Appellant Presentation

Please see the attached Agenda for the February 24, 2026 Santa Barbara County Board of Supervisors meeting. The Appeal of the Promise Land LLC – As-Built Wall is scheduled as Departmental Item No. 4 (see page 20 of the attached Agenda) and is estimated to begin at approximately [1:30 PM]. A summary of the time allocated for this item is also attached to this email.

Unpermitted Wall: Concerns & Questions (1690 San Leandro)

Property Survey
(2021.11.18)

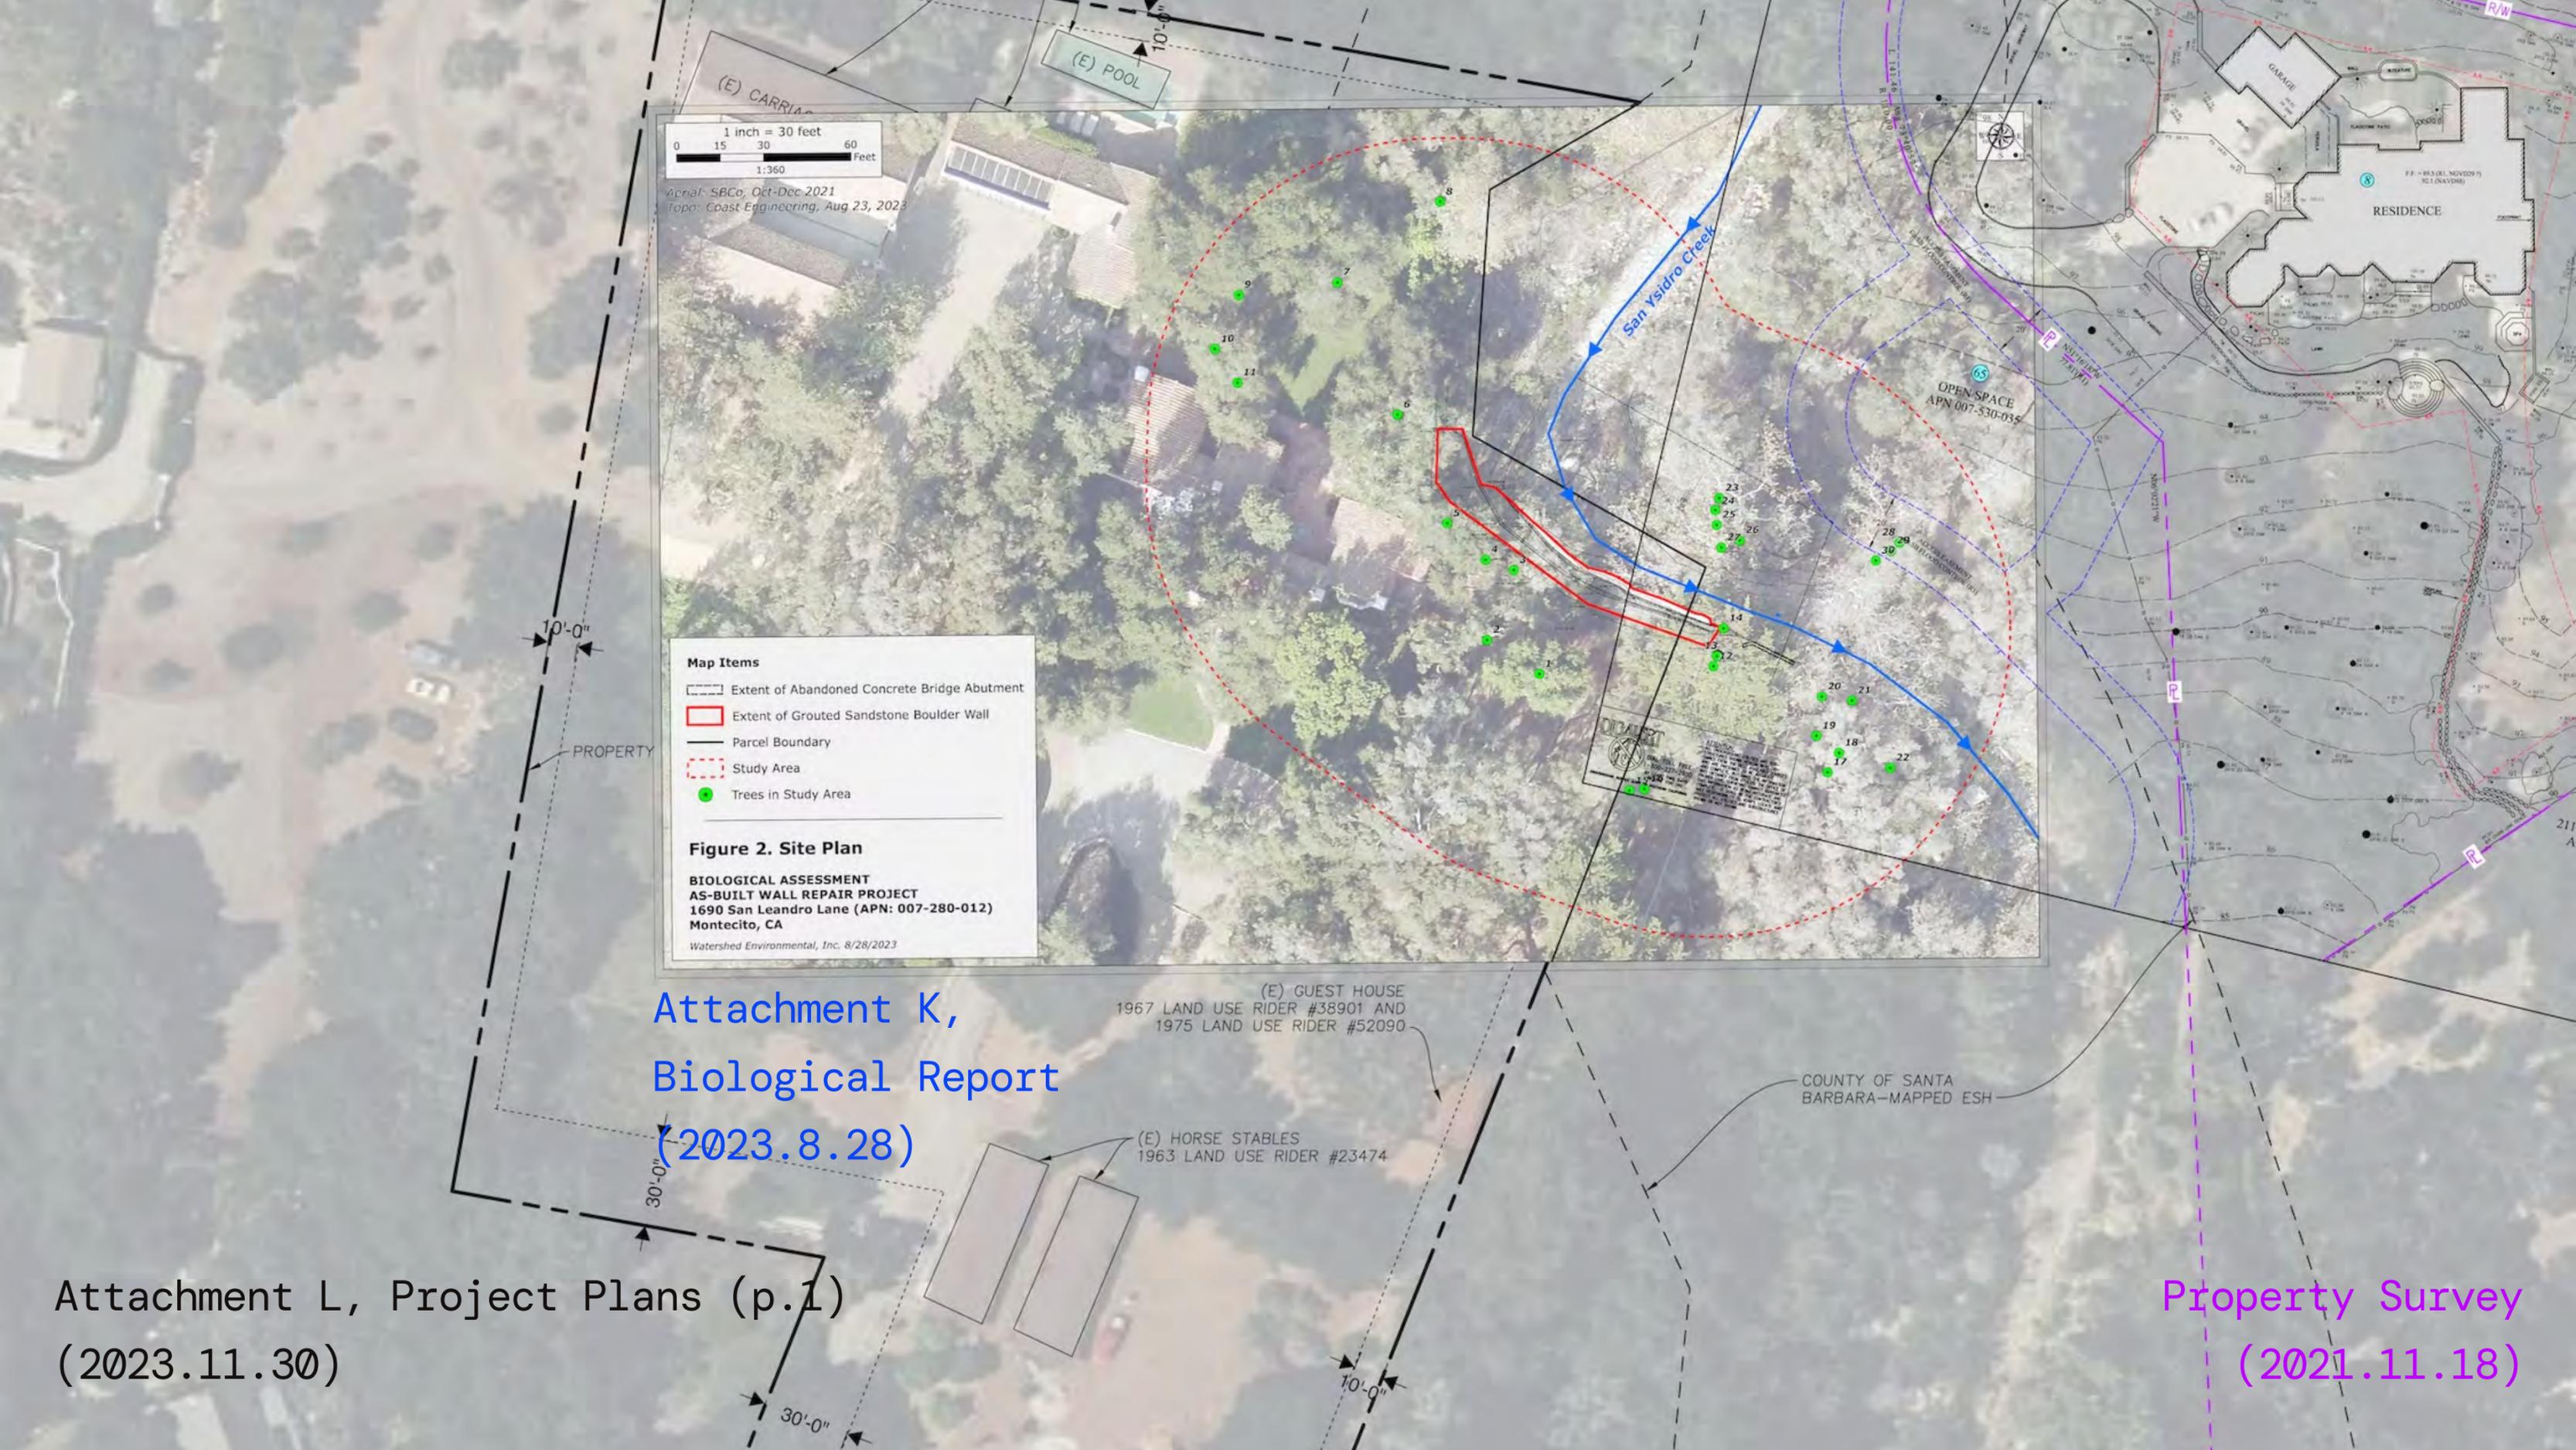
Applicant's own materials shows creak flow is diverted against East Bank, East property lines.

Note: Videos of Deflection in Records (IMG_5276.MOV)

Attachment L, Project Plans (p.1)
(2023.11.30)

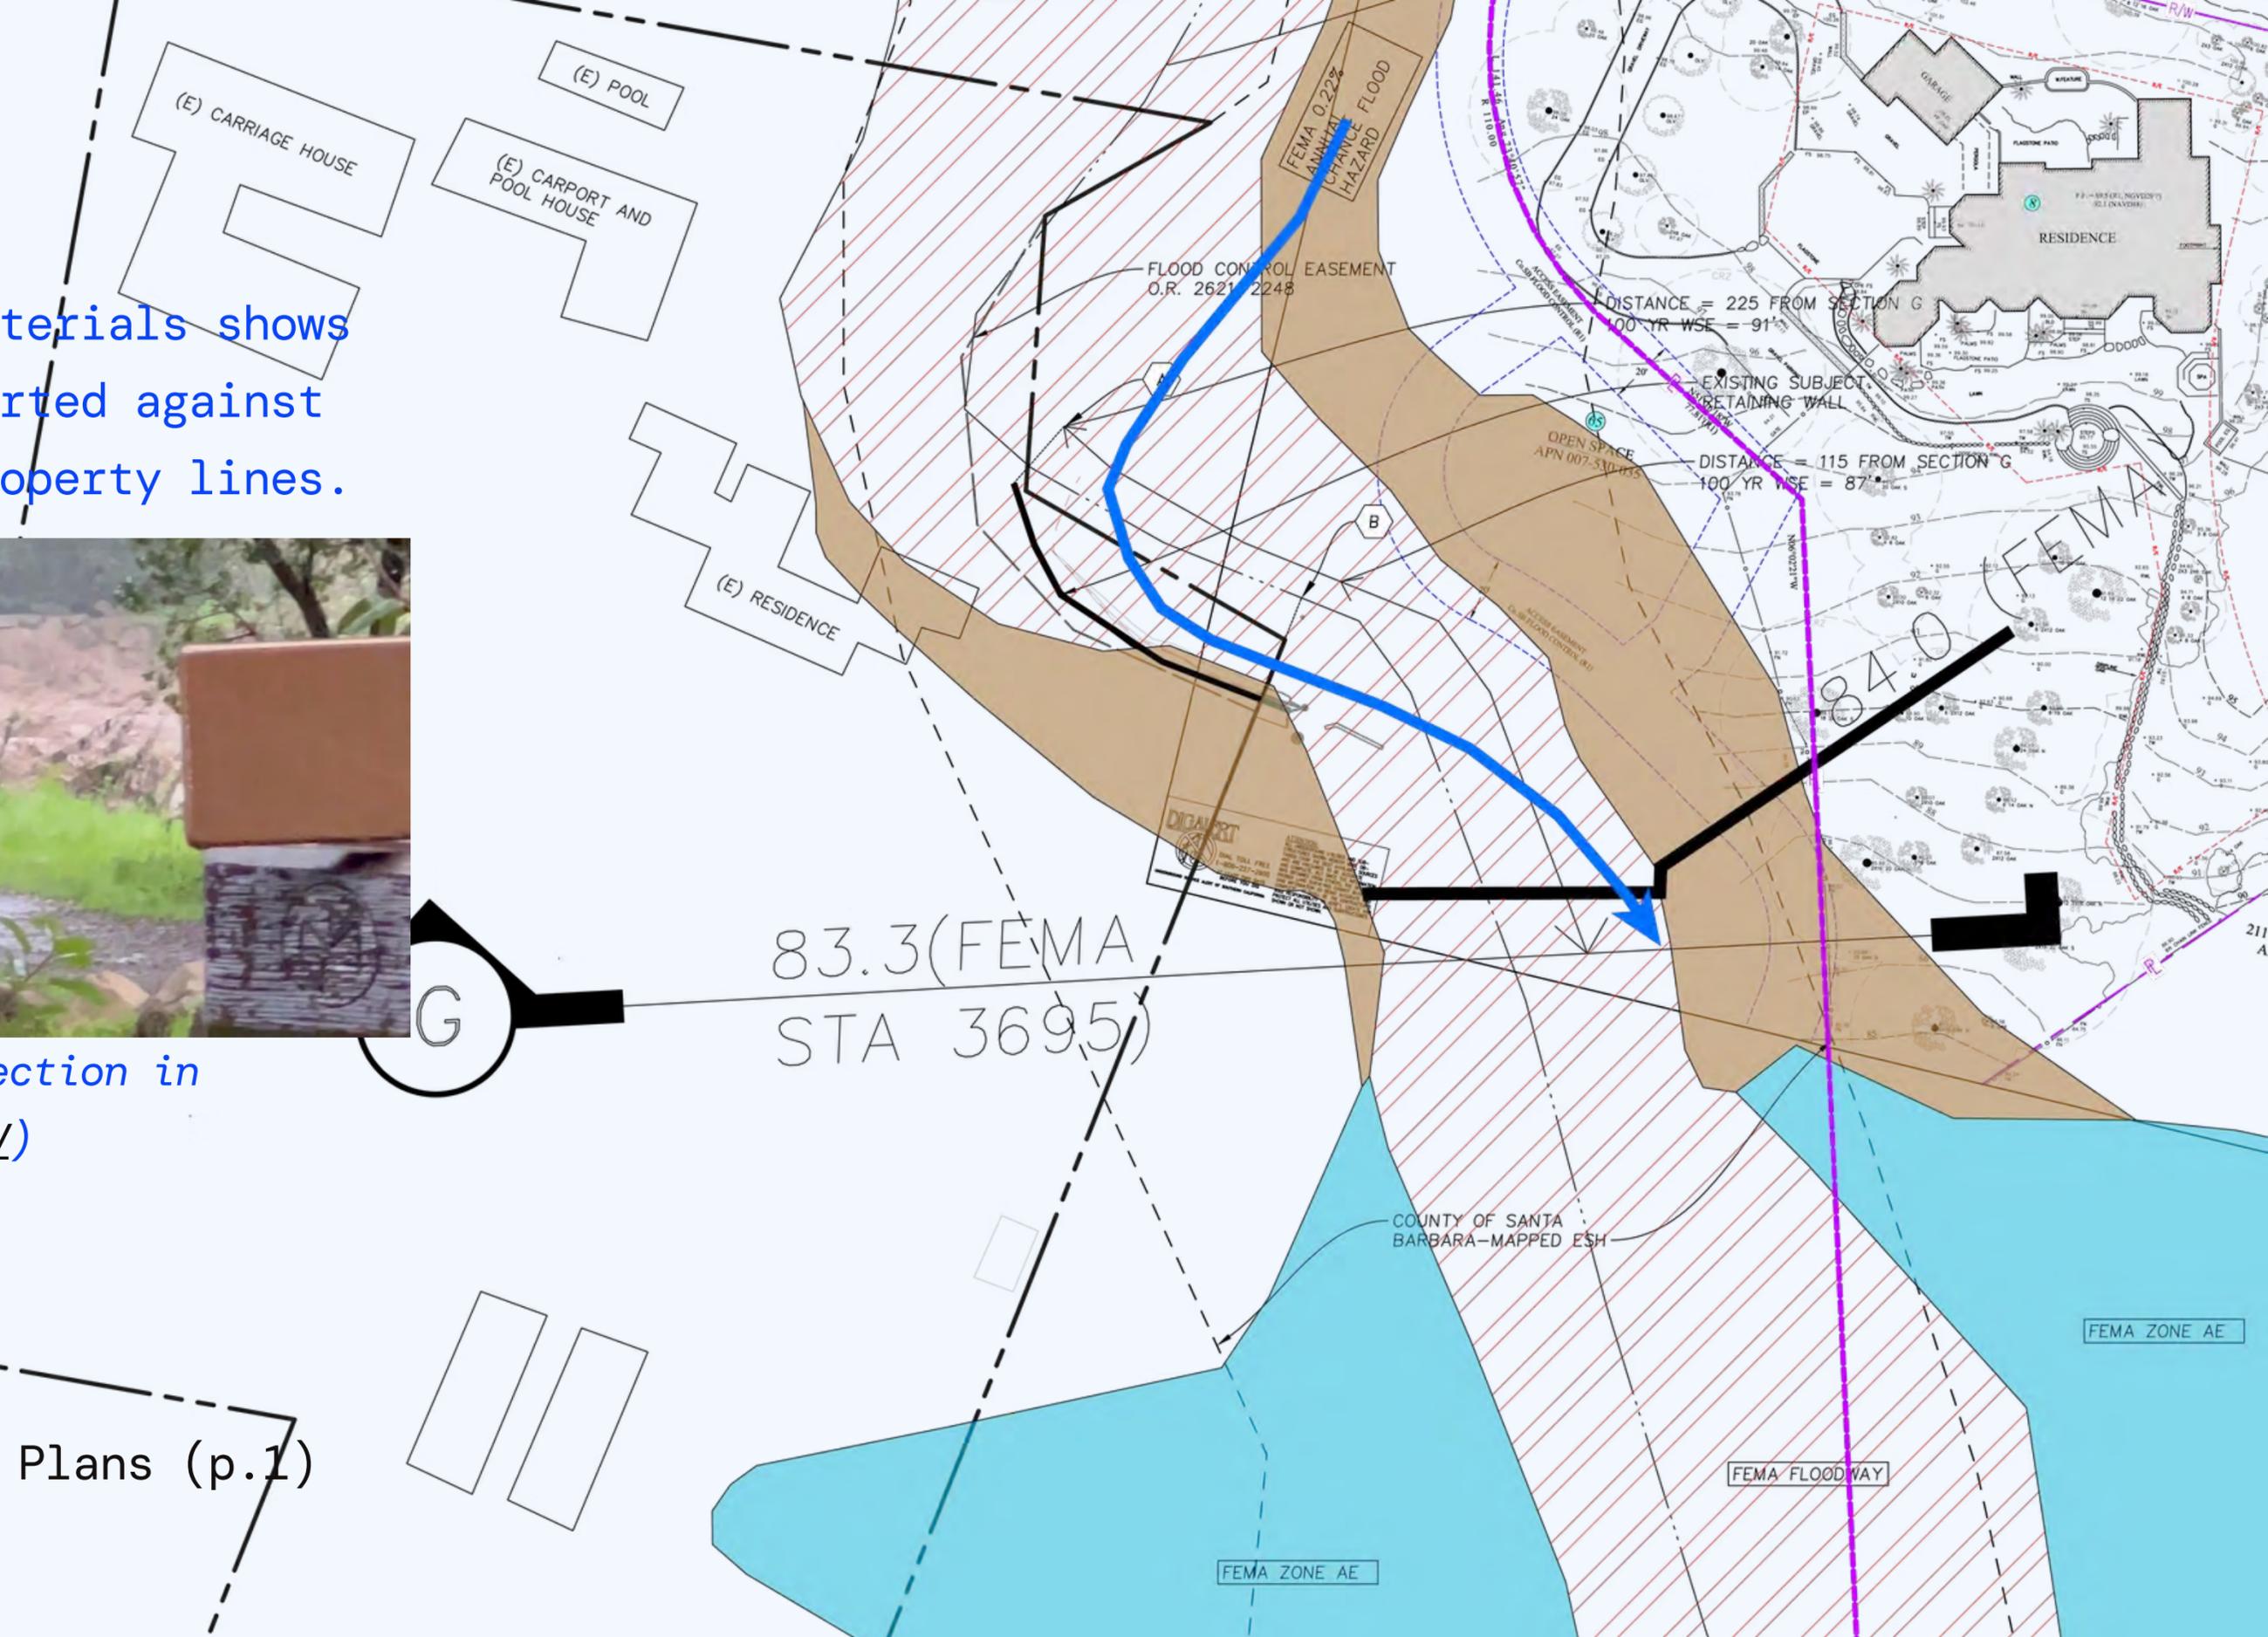
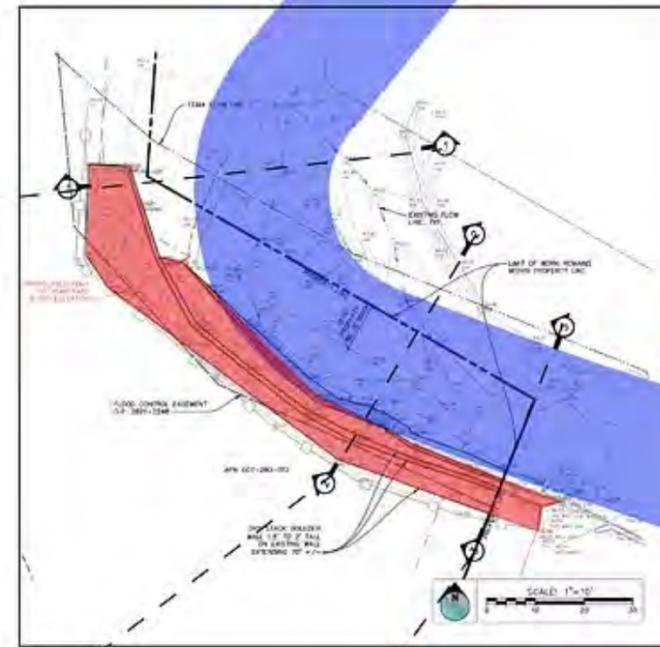
1/9/2023: Imbalanced bank damage begins immediately opposing wall.

* Third layer; not like-for-like. Removed 2025.

1/22/2023: Uneven undercutting
and damage extends downstream of
wall into the Ennisbrook Preserve.

1/22/2023: Displaced boulders and
damage into community trails and
East bank property lines.

1/9/2023: Damages private property, kills protected species, such as native California coastal oaks.

How Does Deflection Change Water Velocity?

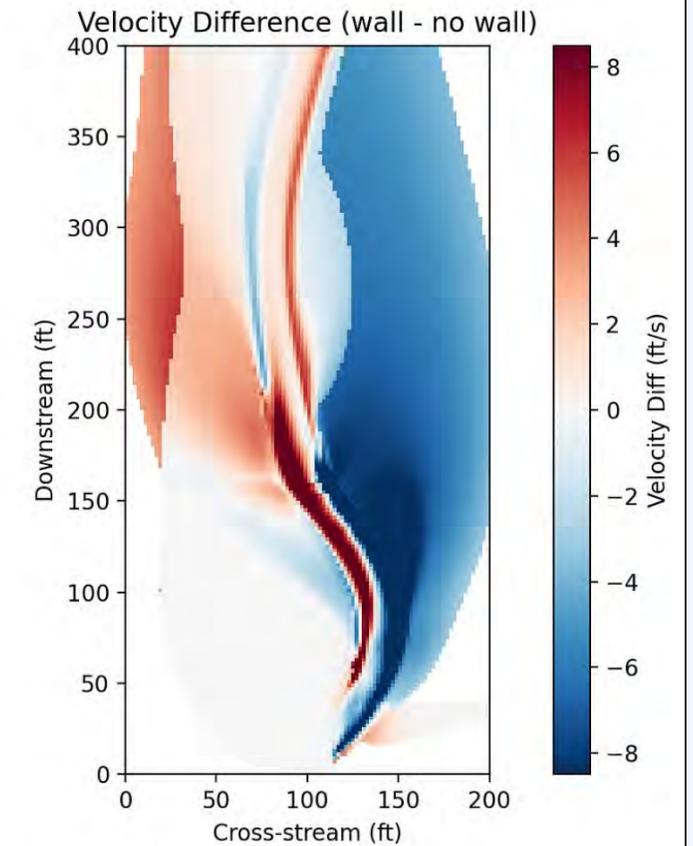
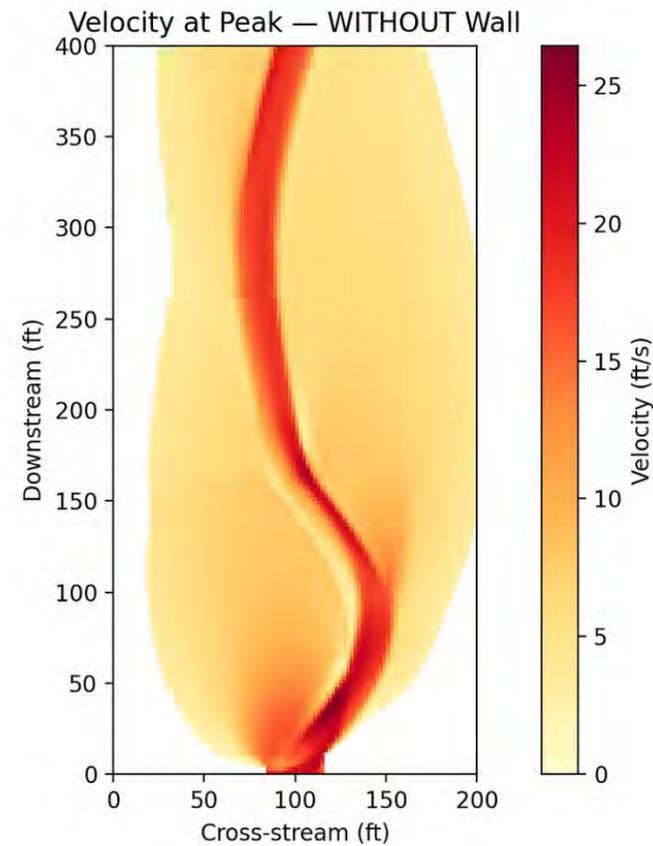
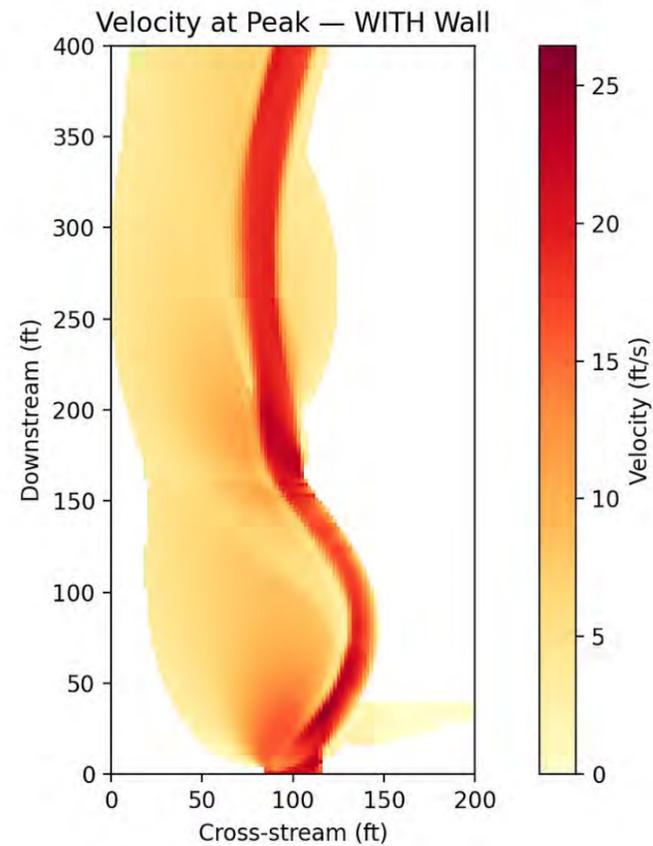
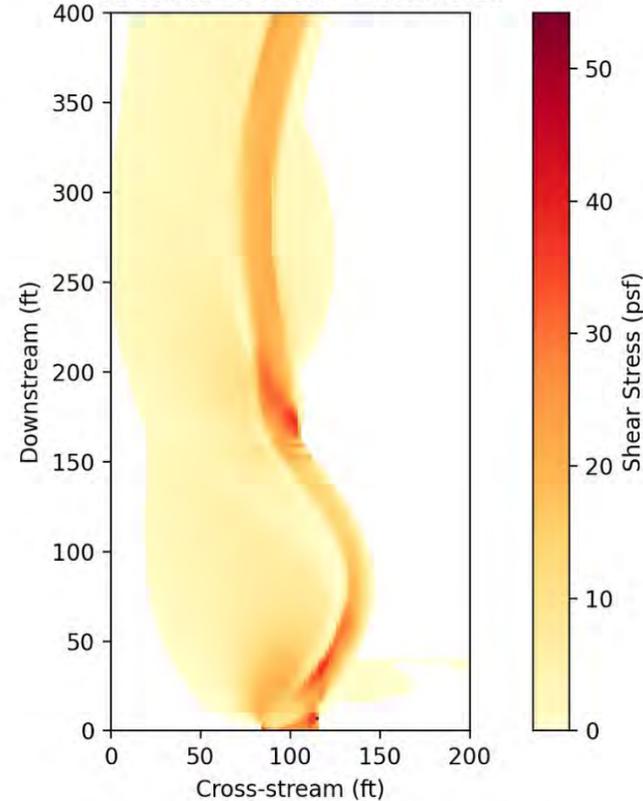
Flow Velocity at Peak Flood — 100-yr Event ($Q = 3,500$ CFS)
(wall: $t=180$ s, no wall: $t=180$ s, $h > 0.5$ ft)

How Does Deflection Affect Shearing?

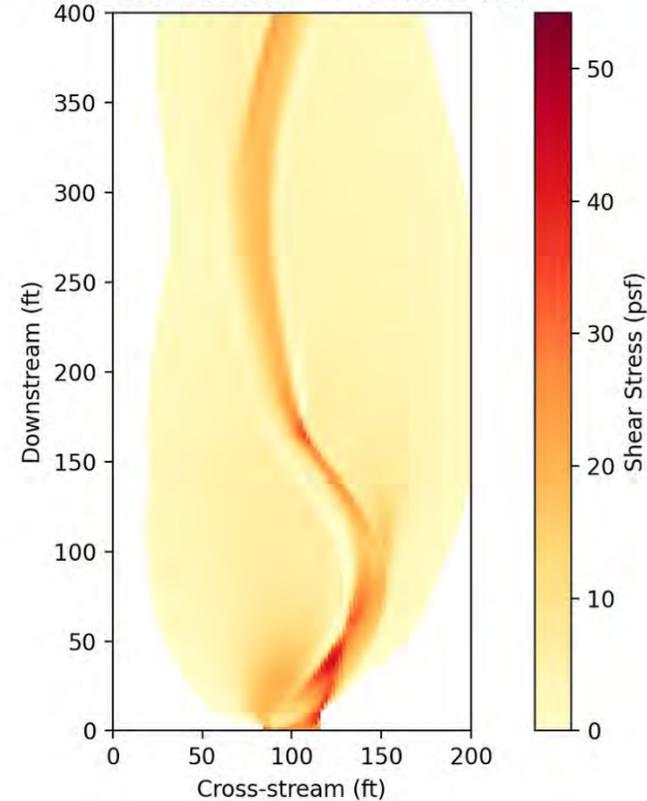
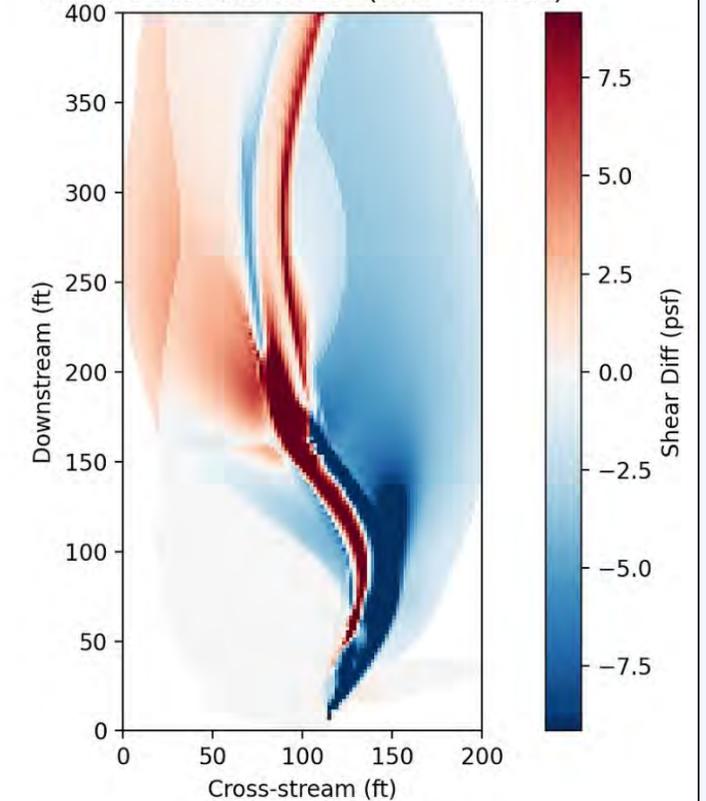
Bed Shear Stress at Peak Flood — Erosion Potential

Bed Shear at Peak — WITH Wall

Bed Shear at Peak — WITHOUT Wall

Shear Stress Difference (wall - no wall)
